Subject: MHI's Response to US-APWR DCD RAI No. 308-2340 Revision 2

MHI's Response to US-APWR DCD RAI No. 308-2340 Revision 2

SRP SECTION: 15.04.01 – UNCONTROLLED CONTROL ROD ASSEMBLY
WITHDRAWAL FROM A SUBCRITICAL OR LOW POWER
STARTUP CONDITION

**Figure 15.4.1-6.1 DNBR versus Time with and without LOOP
Uncontrolled Control Rod Assembly Withdrawal from Subcritical**

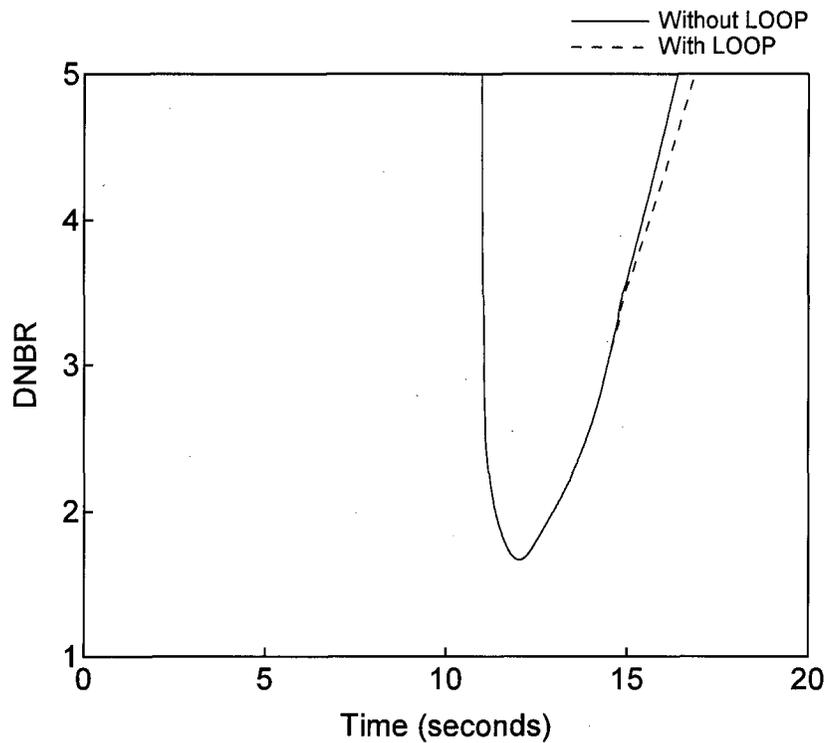
The discussion of bank withdrawal from zero power event does not consider LOOP and neither does the dropped RCCA event, presumably because there is no reactor trip. How do these events take into account LOOP?

For the bank withdrawal from zero power event, the turbine-generator is disconnected. Therefore, the reactor trip will not cause any disturbance to the electrical grid, and there is no need to account for a LOOP. However, for this response, a LOOP is hypothetically assumed to occur 3 seconds after the reactor trip (since the turbine is disconnected). Figure 15.4.1-6.1 below provides the transient DNBR curve and Figure 15.4.1-6.2 below provides the transient fuel centerline temperature for the DCD Subsection 15.4.1 event (bank withdrawal from zero power) considering a LOOP. For comparison, the same event without LOOP is also shown in the figures.
